SEAD-59 AND SEAD-71

PROJECT SCOPING PLAN FOR PERFORMING A CERCLA
REMEDIAL INVESTIGATION/FEASIBILITY STUDY (RI/FS) AT
THE FILL AREA WEST OF BUILDING 135 (SEAD-59), AND THE
ALLEGED PAINT DISPOSAL AREA (SEAD-71), SENECA ARMY
DEPOT ACTIVITY

APRIL 1997

**PROJECT SCOPING PLAN
REMEDIAL INVESTIGATION/FEASIBILITY STUDY
AT SEAD-59 and SEAD-71
SENECA ARMY DEPOT ACTIVITY
ROMULUS, NEW YORK**

FIGURE 3-15
GROUNDWATER ELEVATION MAP

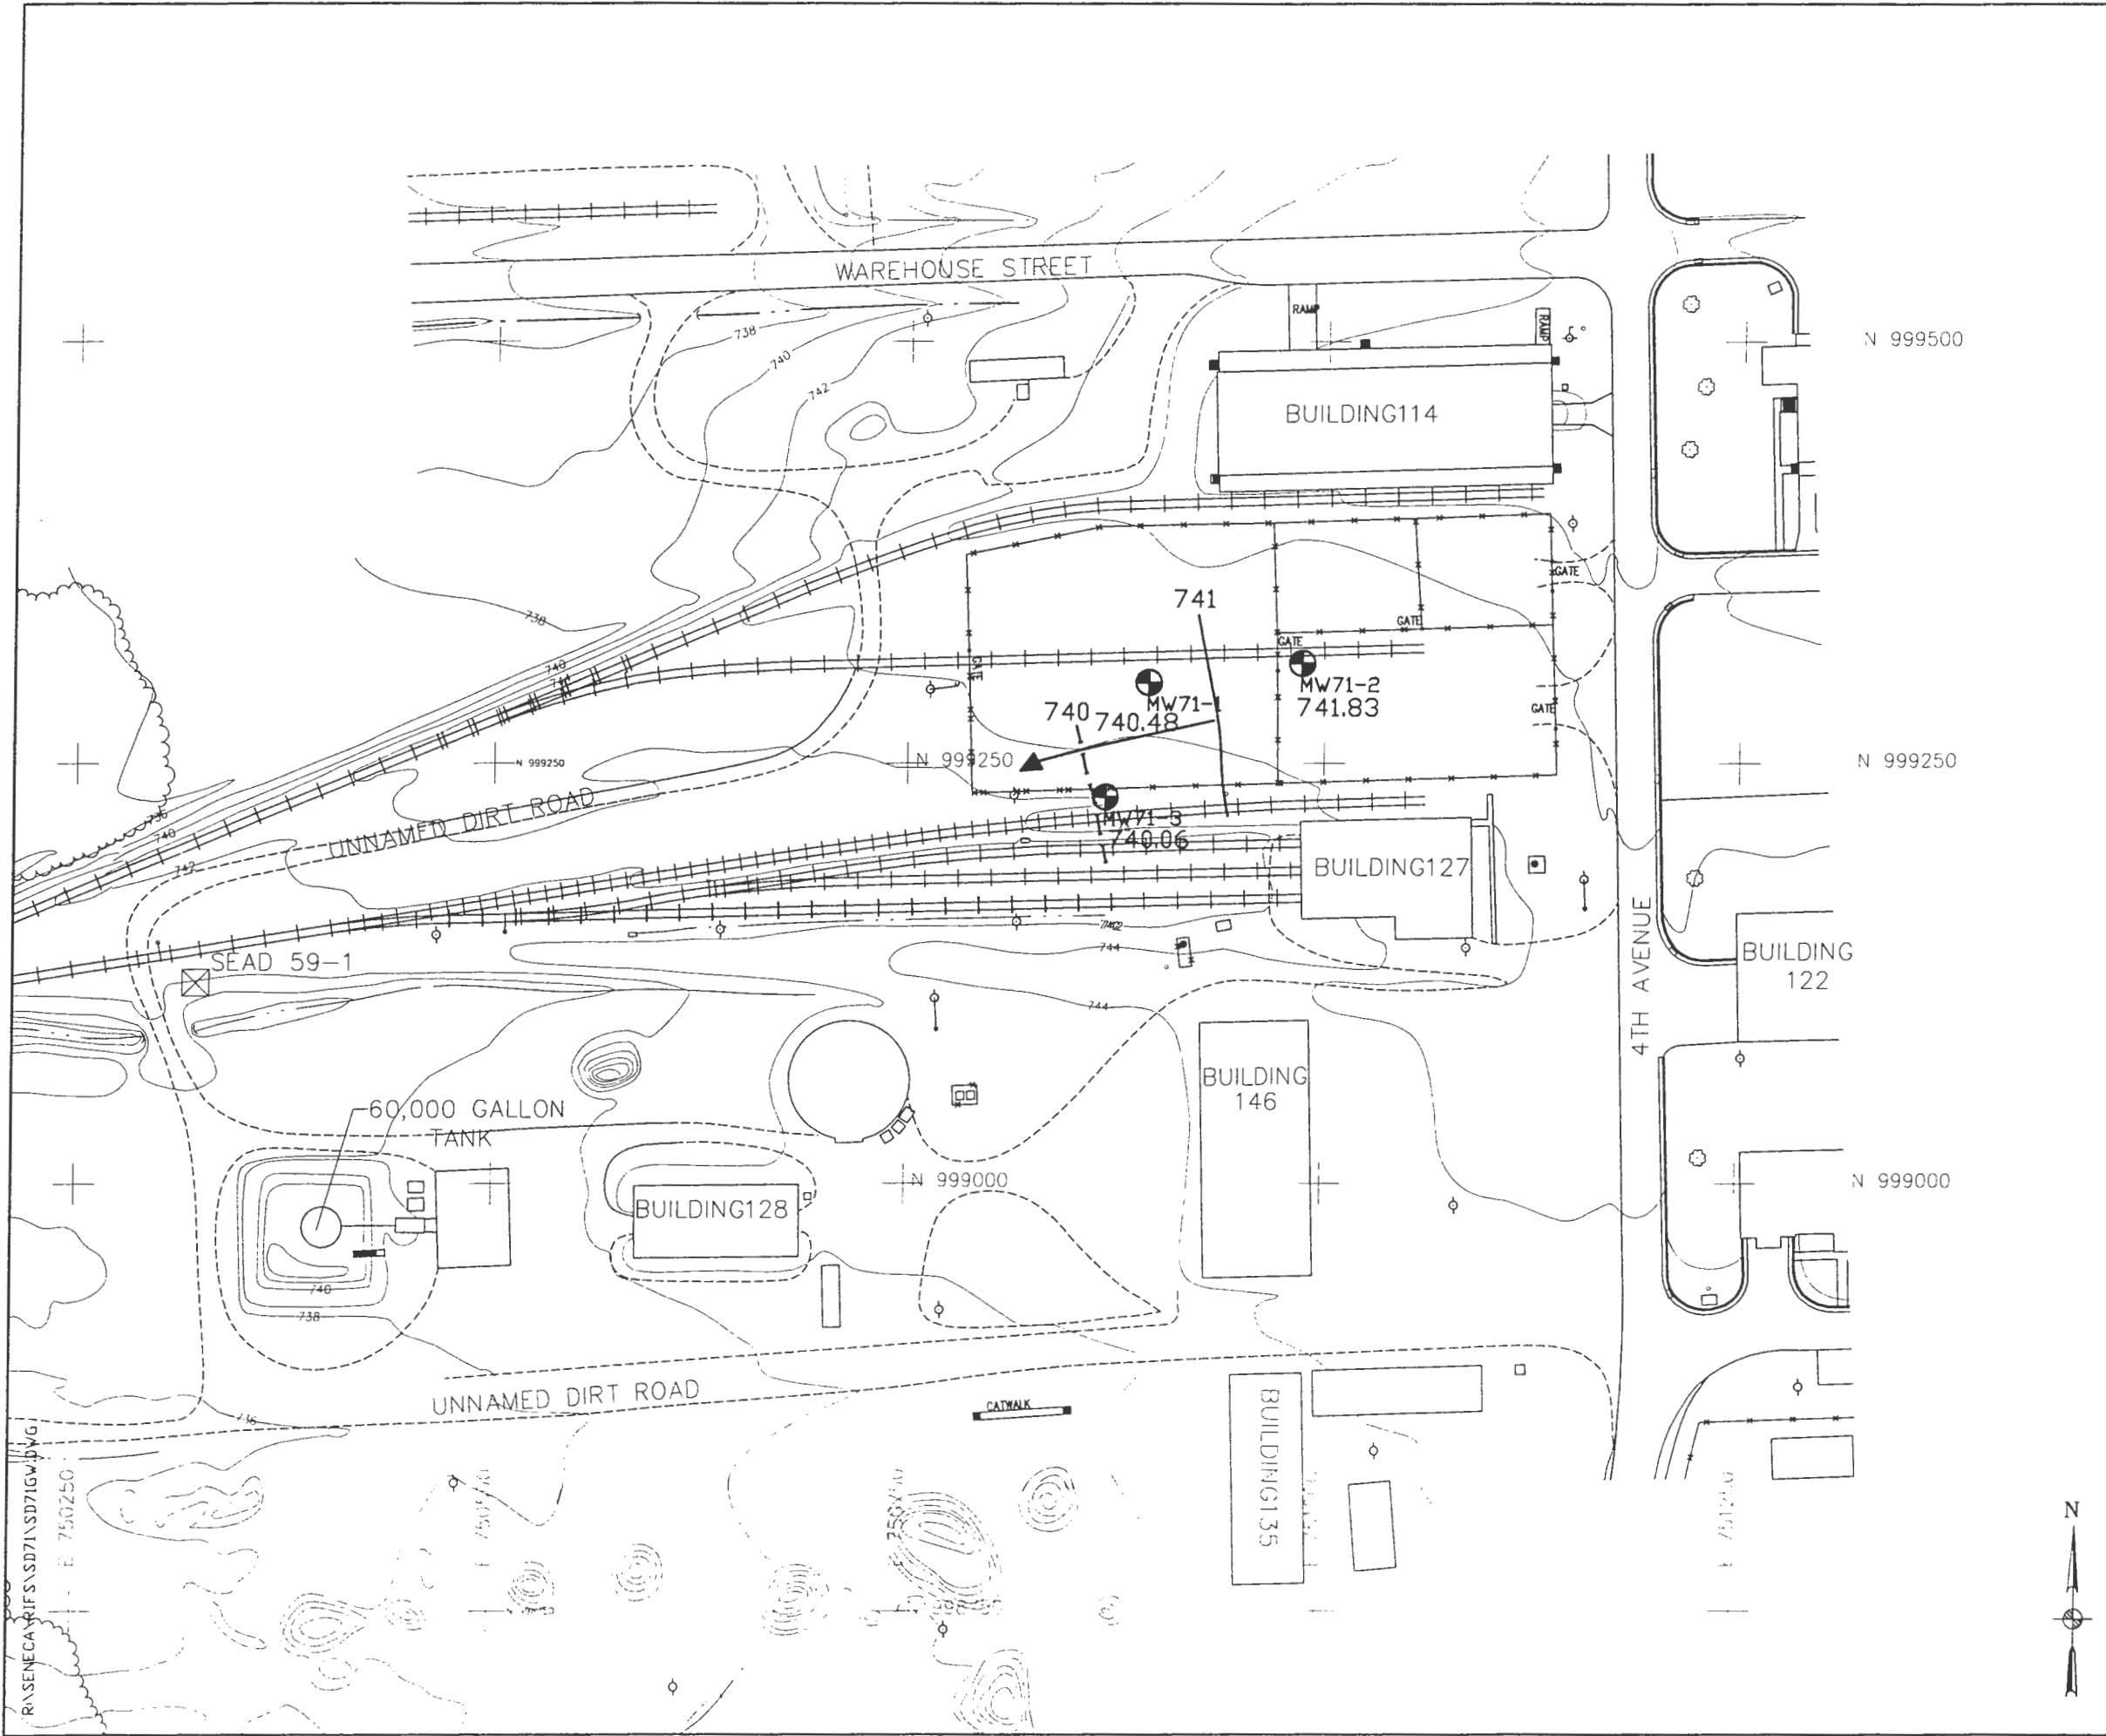
Figure 3-19: It is unclear what control was used to construct the 740 foot contour line presented on this figure.

- Response #7** Agreed. The groundwater contours in Figure 3-16 (formerly 3-20) have been revised so that they are the same as those shown in Figure 3-15 (formerly Figure 3-19).

FIGURE 4-1
 LOCATION OF EXISTING AND
 PROPOSED SAMPLING POINTS

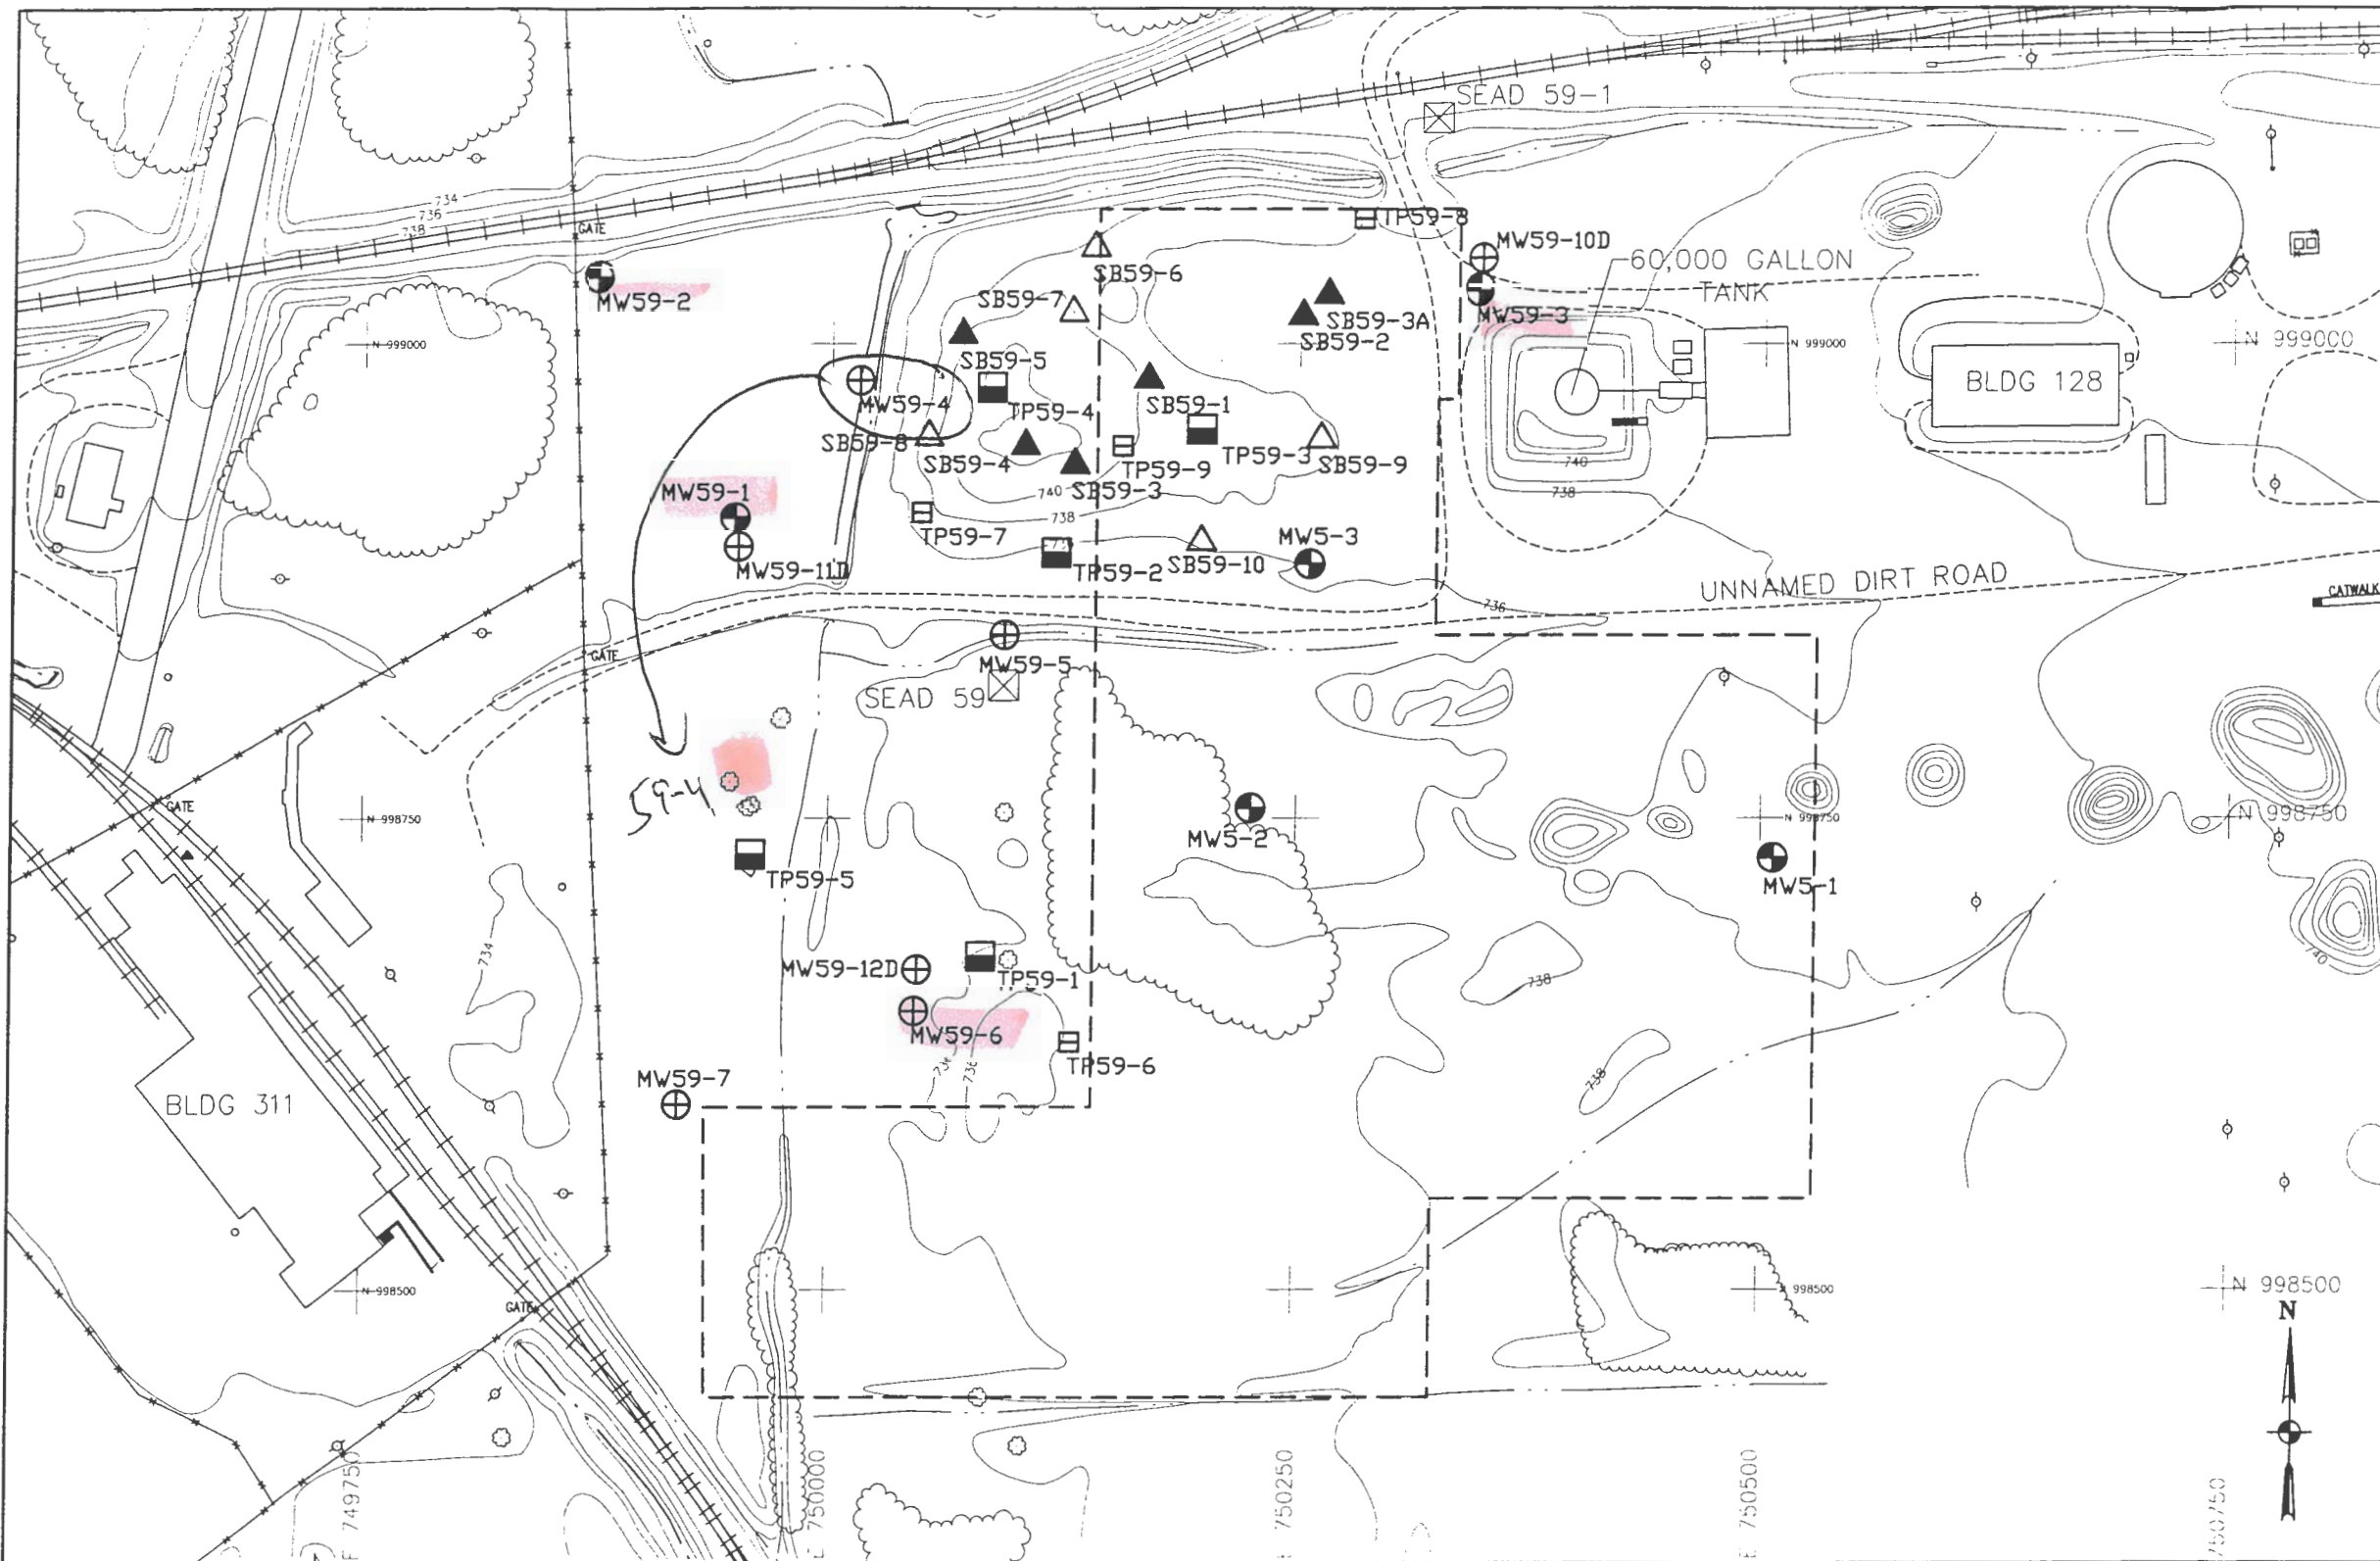
- Comment #19** Figures 4-3: As with Figure 4-5, groundwater contours should be shown on this Figure. Also the locations of monitoring wells MW5-1, MW5-2, and MW5-3 should be shown on this Figure as they are on Figures 3-11 and 3-12. The rationale for the proposed location of monitoring well MW59-6 should be provided. The proposed location for this well is approximately 60 feet from Test Pit TP59-6 in which 2,100,00 ug/kg of BTEX was present. Proposed well MW59-6 should be moved next to this test pit in order to better characterize groundwater quality in this area.

Response #15 Acknowledged. The locations of the additional surface water and sediment samples SW/SD59-5 and SW/SD59-13 are shown on Figure 4-1 (formerly Figure 4-3). The text has been revised so that it is clear which samples are the two nearby off-site samples.

- Response #16** Agreed. To address possible vertical impacts at the site three (3) shallow bedrock monitoring wells have been proposed. Two of the bedrock wells are proposed in downgradient locations and one is proposed as a background location. The text in Section 4.2.5.1 and Figure 4-1 were revised to reflect this change in the field program.

- Response #19** Agreed. The wells MW5-1, MW5-2, and MW5-3 were added to this figure. Also, well MW59-6 was moved so that it is closer to test pit TP59-6 as recommended in the comment. But, we do not believe that it is necessary to show the groundwater contours on this map because this would make the map look cluttered and more difficult to read; however, the groundwater contours are shown on Figure 3-7. The location of this well on Figure 4-1 was revised.

Response #1 Agreed. The Scoping Plan currently calls for a till/weathered shale well near TP59-1, and based on EPA comments this wells has been moved even closer to the test pit location; also, a bedrock well is proposed for this location as well. Because the comment suggests that multiple wells will be necessary to define the extent of the possible VOC impacts in groundwater, another well has been proposed to be installed even farther downgradient of TP59-1, near the SEAD-59 boundary. The text in Section 4.2.5 was revised as well as Figure 4-1.
